ADDENDUM NO. 1
BASEBALL AND SOFTBALL COMPLEX RENEWAL
FOR GADSDEN STATE COMMUNITY COLLEGE
Architect Job No. 23-66
November 30, 2023
ACCS No. 2023 063 GSCC

The Plans and Specifications are hereby amended. The following supersedes all contrary and/or conflicting information and is made part of the contract documents.

1
SP3.0
DRAINAGE PLAN
Scale: 1" = 30'-0"

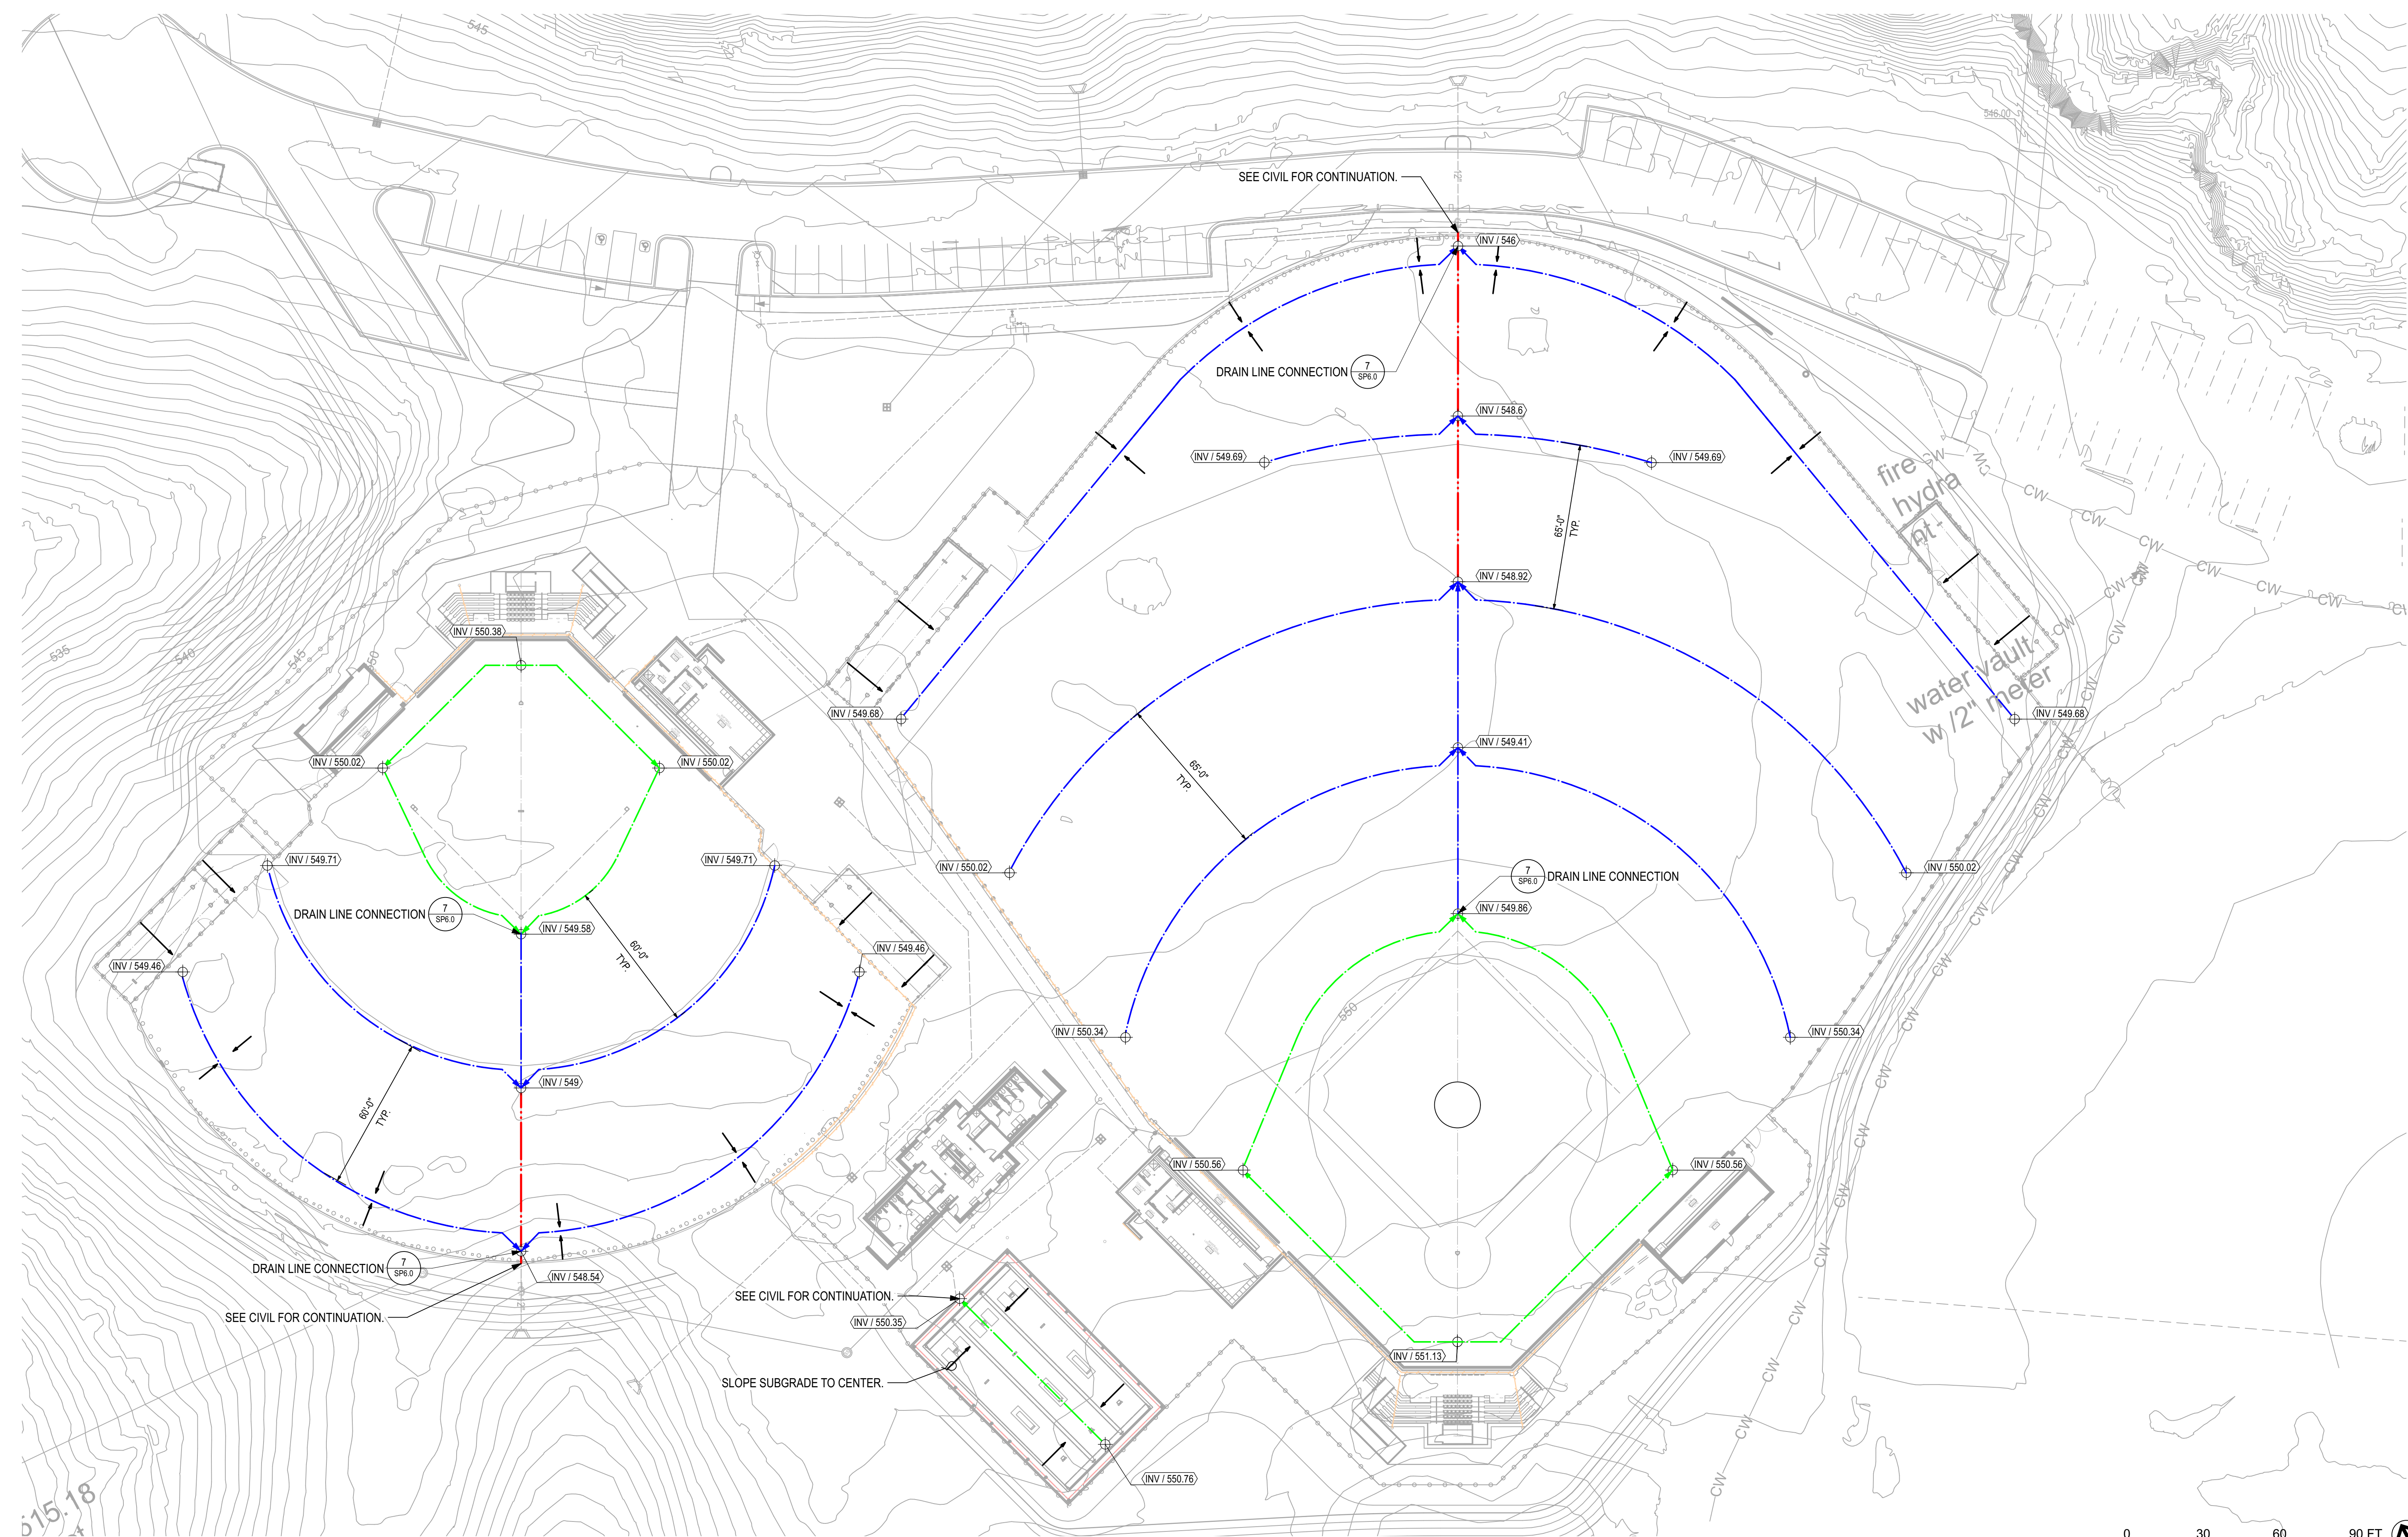
8. Sheet **SP3.0** – SUBSURFACE DRAINAGE PLAN:
 - A. Revised sheet to update background to reflect Civil Drainage Plan.
 - B. Revised sheet to add note “SEE CIVIL FOR CONTINUATION”

- C. Revised sheet to add note “SLOPE SUBGRADE TO CENTER”
 - D. Revised sheet to add inverts at hitting tunnel center drain line.
9. Sheet **SP6.0** – DETAILS revised detail 3 to add note, “CURB HEIGHT MAY VARY IN SOME AREAS, SEE CIVIL PLANS.”

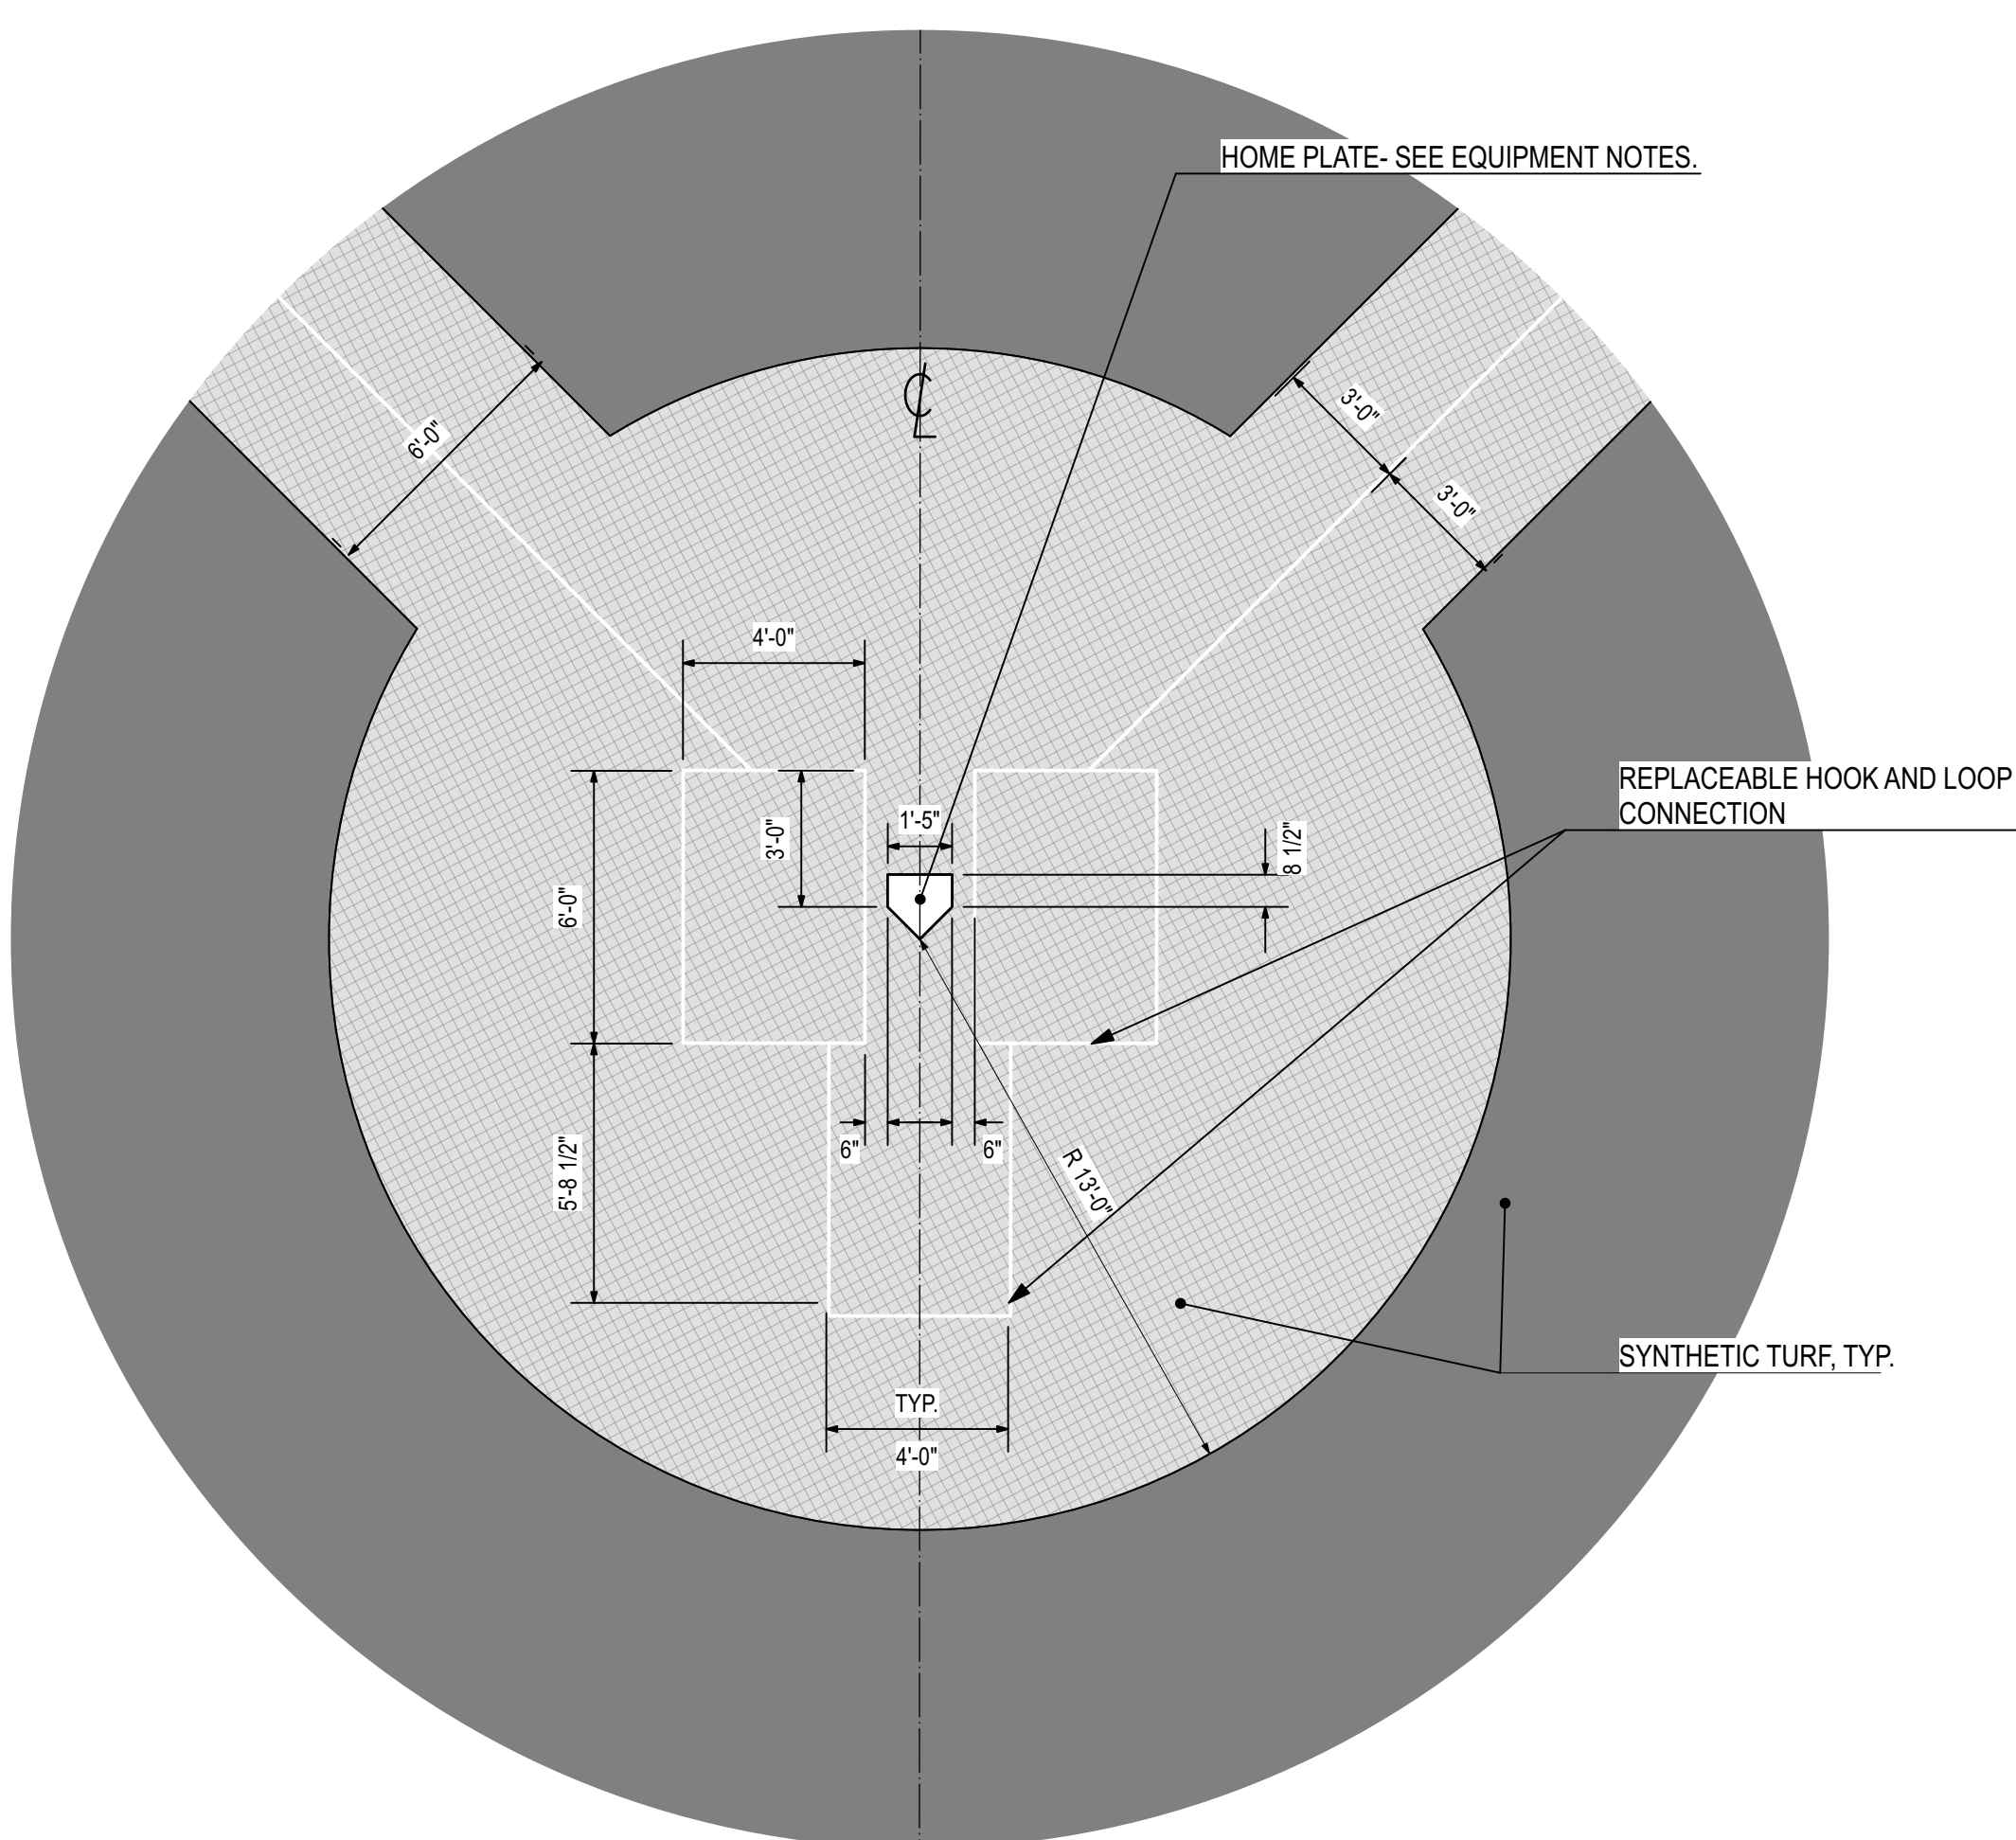
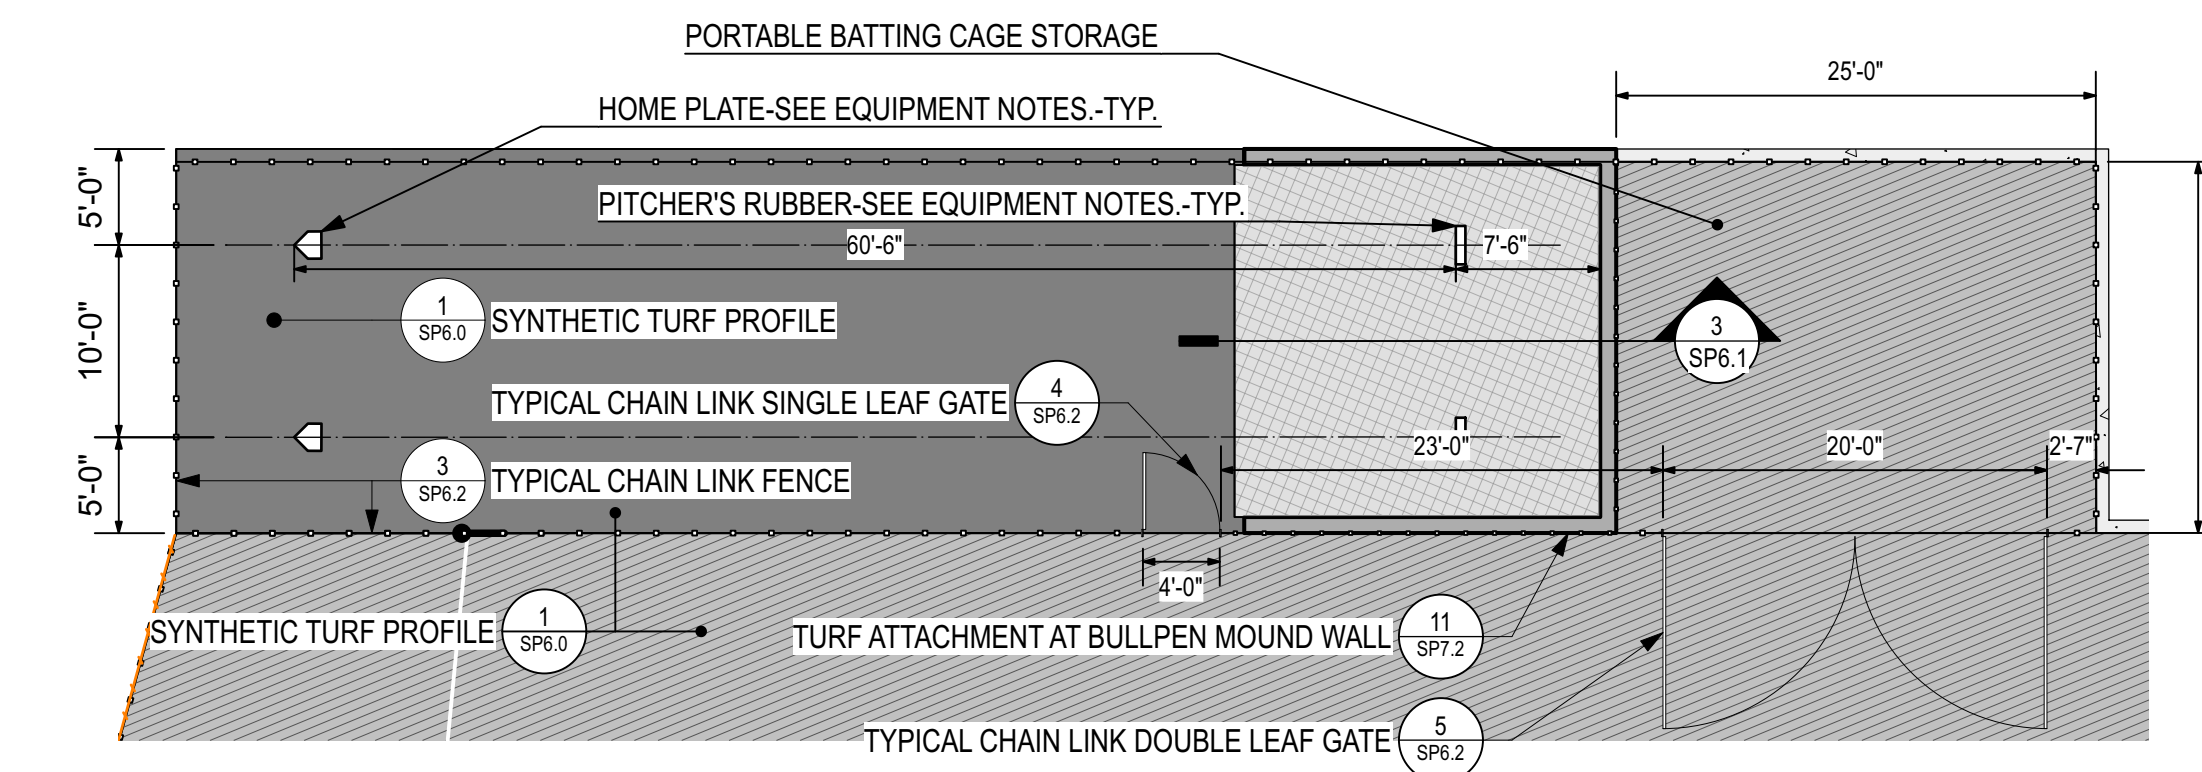
10. Sheet **SP6.1** – DETAILS revised sheet Detail 8 and 9 to add note, “(3) BAY TENSION BATTING TUNNEL-SEE EQUIPMENT NOTES.”
11. Sheet **L7.0** – LANDSCAPE PLAN:
